## HISTORIC AND DESIGN REVIEW COMMISSION

September 06, 2017

**HDRC CASE NO:** 2017-423  
**ADDRESS:** 3903 N ST MARYS / SAN ANTONIO ZOO  
**LEGAL DESCRIPTION:**  
**ZONING:** R-6,HS  
**CITY COUNCIL DIST.:** 2  
**LANDMARK:** Brackenridge Park  
**APPLICANT:** Michael Rey, AIA/Overland Partners  
**OWNER:** San Antonio Zoo  
**TYPE OF WORK:** Construction of an addition to an existing veterinary structure  
**REQUEST:**

The applicant is requesting a Certificate of Appropriateness for approval to construct an addition to the existing veterinary facility at the San Antonio zoo to feature 1, 250 square feet.

# FLOOR PLAN

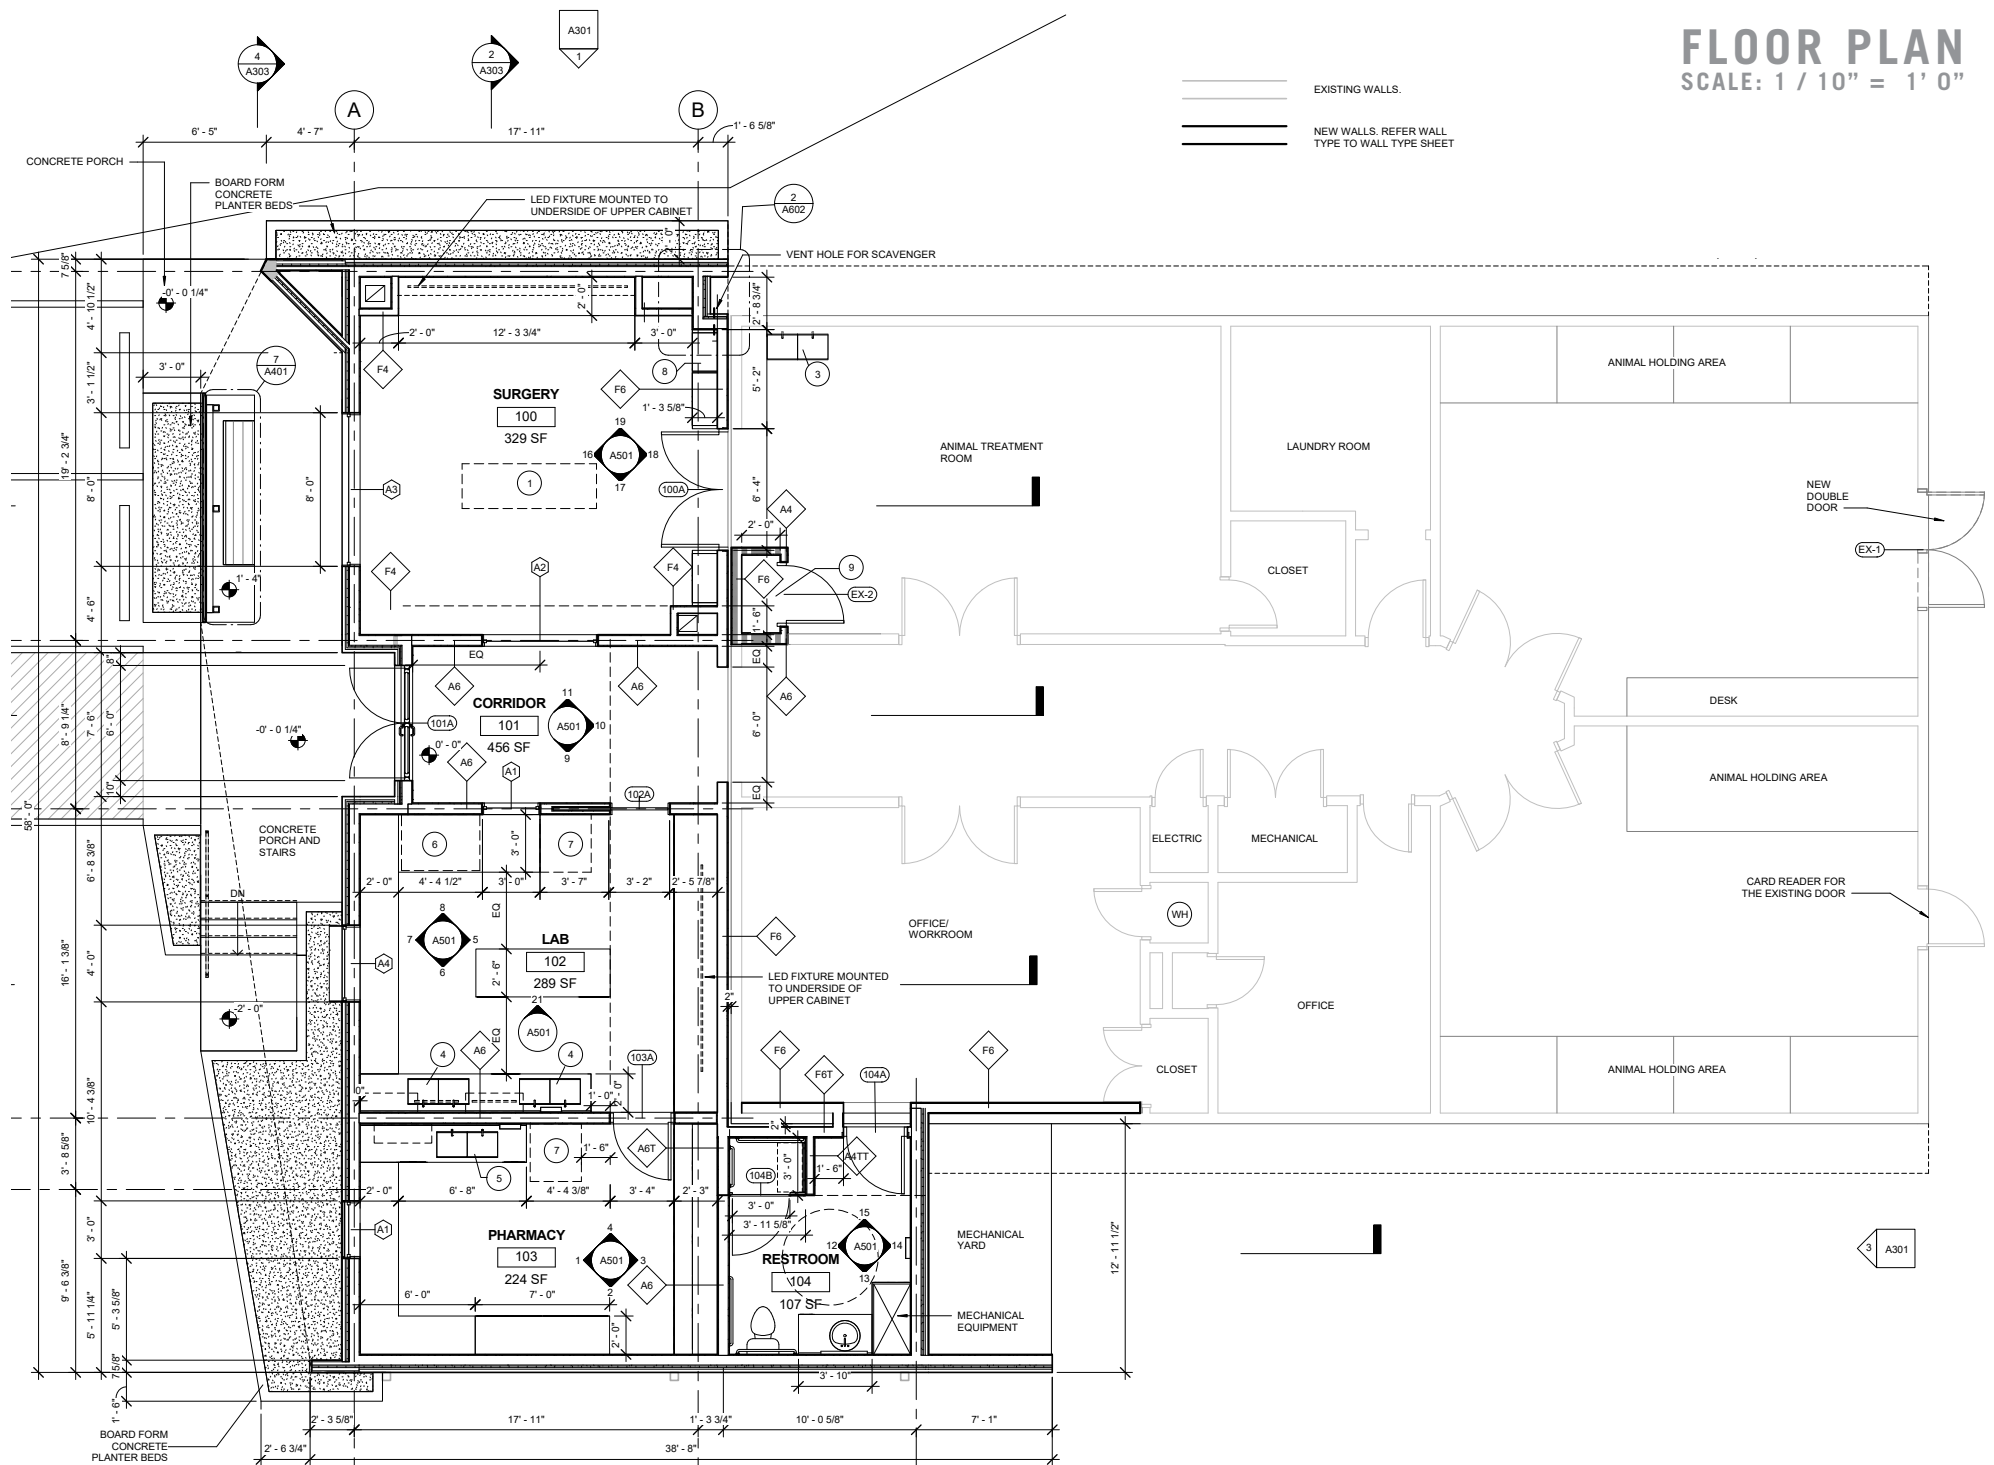
- b. ADDITION – The applicant has proposed to construct the proposed addition at the front of the existing structure. Staff finds the location of the proposed addition to be appropriate. The addition will improve the overall architectural character of the structure, will provide a human scale to the front façade and will introduce materials appropriate materials. This is consistent with the UDC.

# NORTH / SOUTH ELEVATIONS

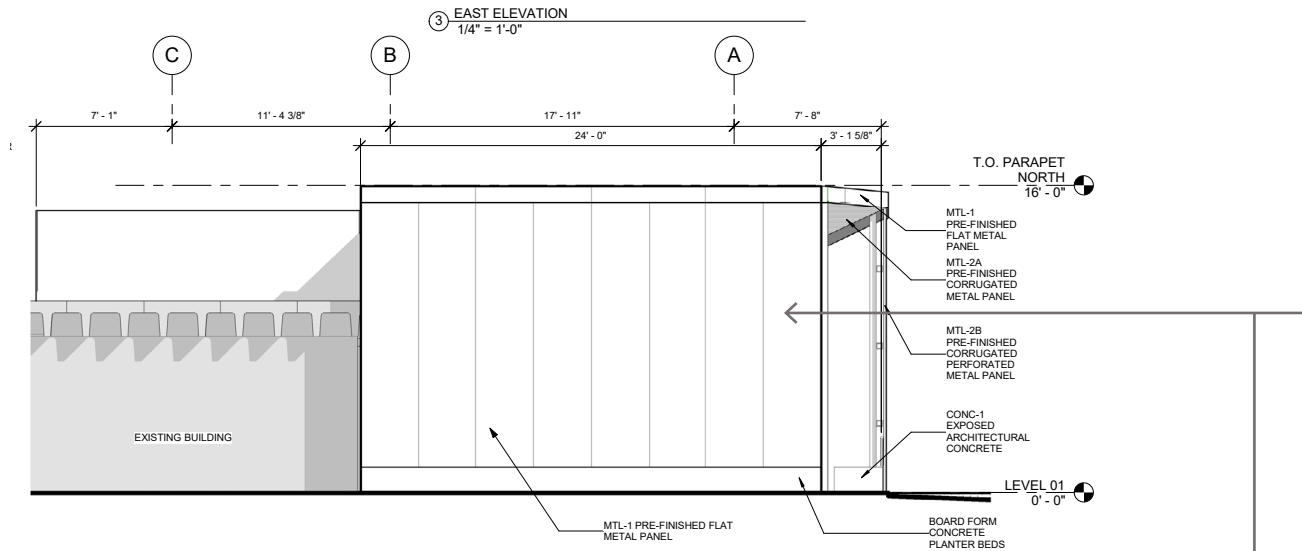
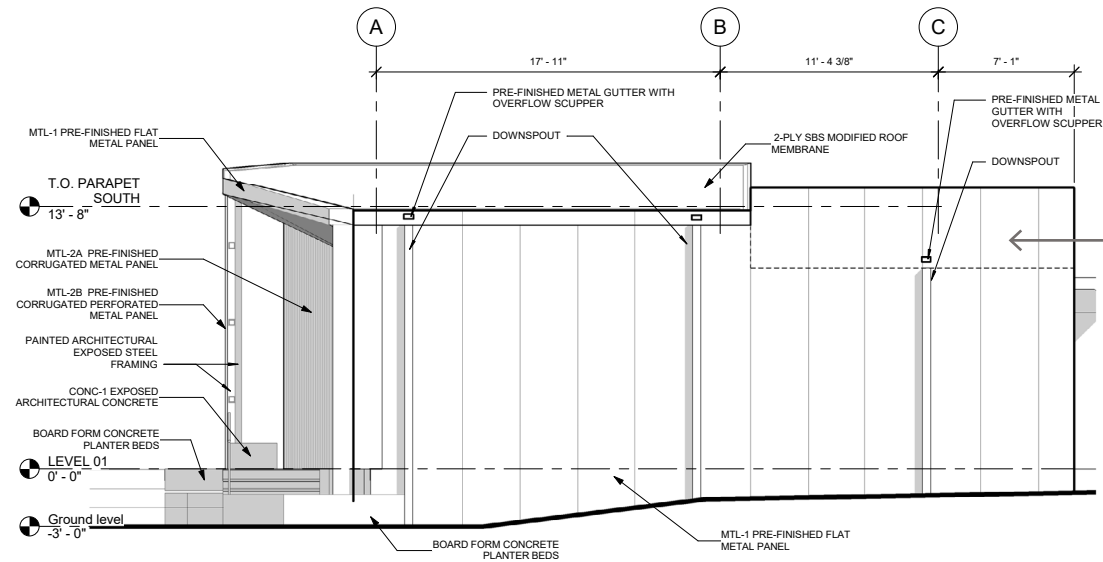
- d. MATERIALS – The applicant has proposed materials to include flat metal panels, board form concrete planters, metal fascias, perforated metal panels, corrugated panels and aluminum windows and doors. The proposed materials are consistent with the UDC Section 35-674(d).
